# Metropolitan Development Commission Regional Center Hearing Examiner (June 27, 2024) Meeting Agenda

## STAFF REPORT

<b>Case Number</b>	2024-REG-016B
<b>Address (approx.)</b>	501 Indiana Avenue
<b>Location</b>	Center Township, Council District # 12
<b>Petitioner</b>	Indiana Avenue Partners, LLC., by Chris Mulloy
<b>Zoning</b>	CBD-2 (RC)
<b>Request</b>	Regional Center Approval to provide for: Construction of a 12-story mixed-use development, consisting of 263 dwelling units, 323 parking spaces within a parking garage, and approximately 35,475 square feet of amenity space, office space, and retail space.

<b>Case Number</b>	2024-REG-028
<b>Address (approx.)</b>	639 South Delaware Street
<b>Location</b>	Center Township, Councilmanic District # 18
<b>Petitioner</b>	Eli Lilly and Company, by Andi M. Metzger
<b>Zoning</b>	I-3 (RC)
<b>Request</b>	Regional Center Approval to provide for a 775-person, two-story conference center, within an existing corporate campus.

DEVELOPMENT DOCUMENTS  
 501 Indiana Avenue  
 Indianapolis, IN 46204  
 SITE PLANTING PLAN

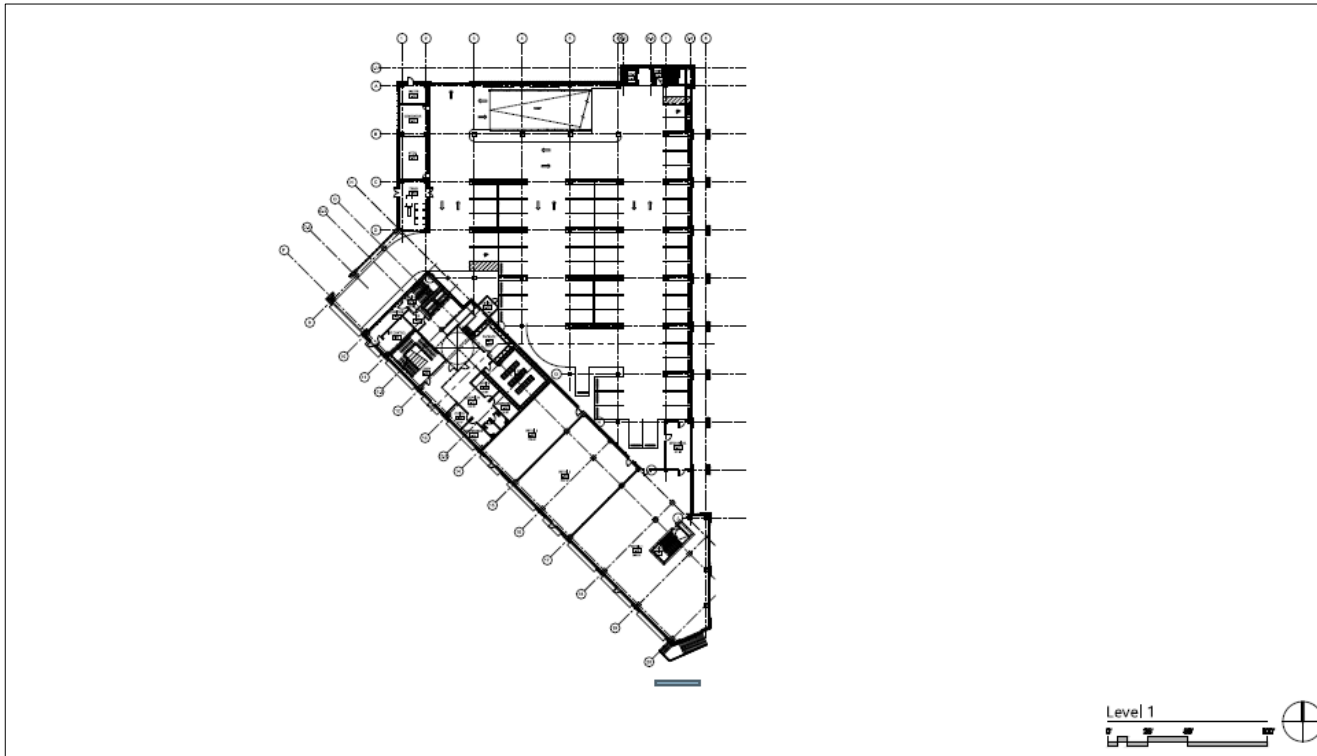
4. An amended landscape plan shall be submitted and subject to staff review and approval, prior to installation. Said landscape plan shall identify specific flora species. See CA 4.6.1 and CA 4.6.4.

Sub-Level 1: Canal Level

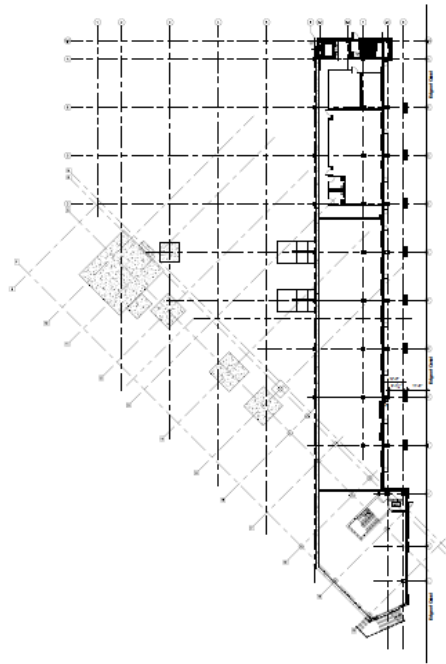
4. The canal level floor plan does not identify room labels, such as use for retail, amenity, etc. This level is adjacent to the Central Canal and a highly used pedestrian way. An amended canal level floor shall be submitted prior to the hearing. See SC 1.3.1, SC 1.3.2, SC 2.1.1, and SC 2.2.1.

**Southwest Elevation**  
0' 16' 32' 64'

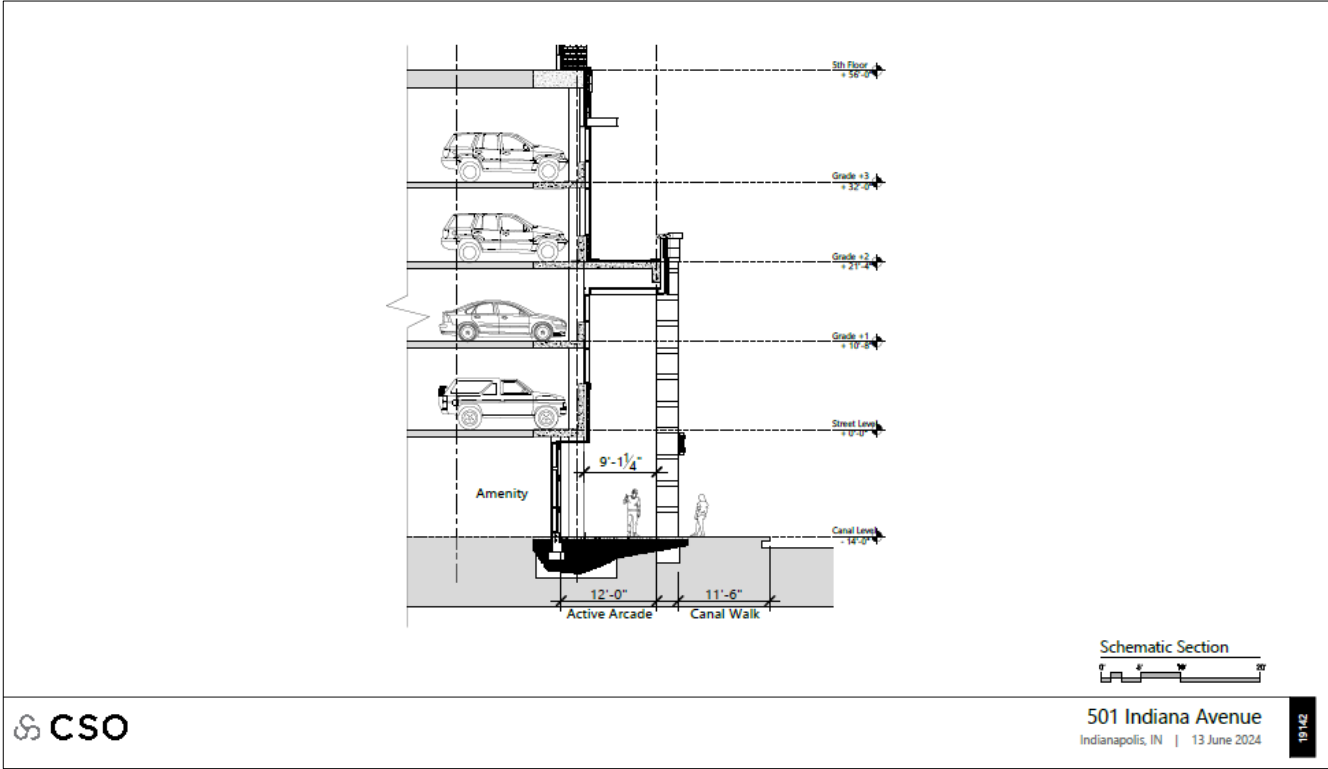
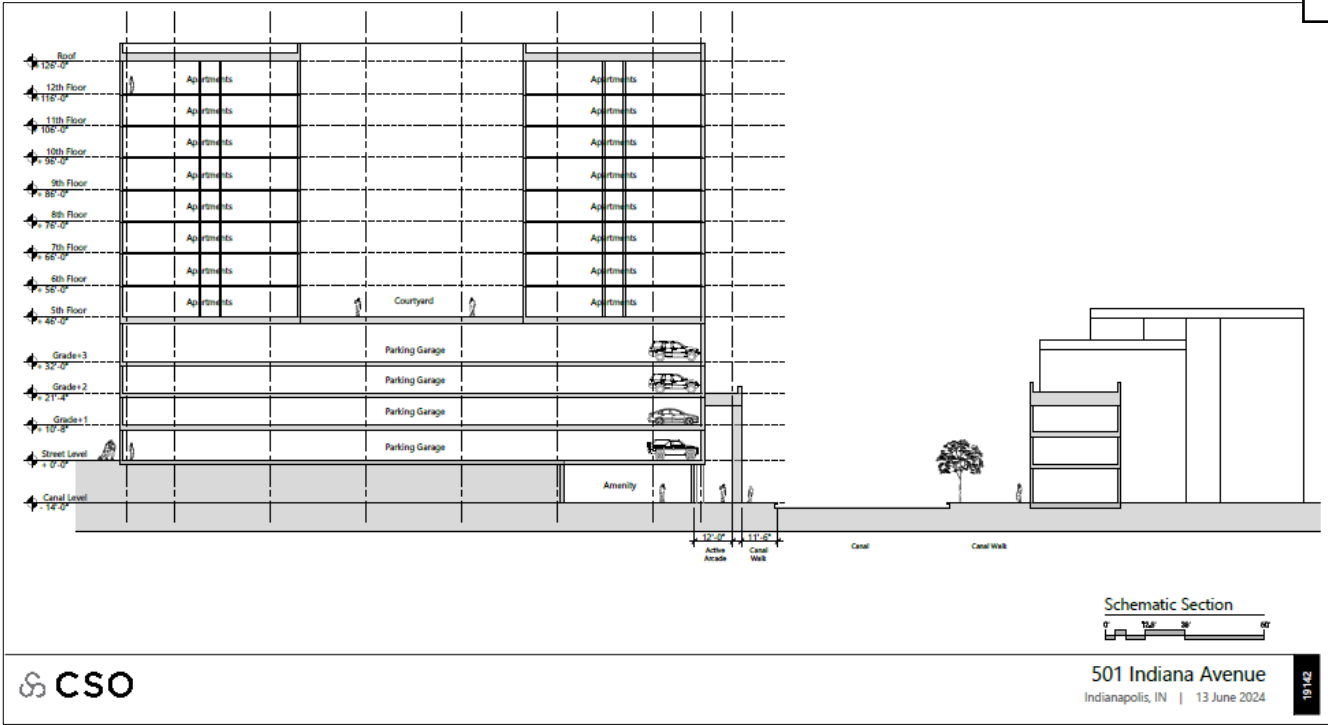
3. The east elevation includes two areas where mechanical equipment would be shielded with the use of metal louvers, and the mechanical room also appears to be in a different location than shown on the plans. This must be clarified, prior to approval of this request. Additionally, staff is concerned with the use of a large new building material in place of storefront windows. See CA 1.2.1, CA 2.1.1, CA 2.1.2, CA 2.2.1, CA 2.3.1, CA 2.3.2, and CA 4.4.1.
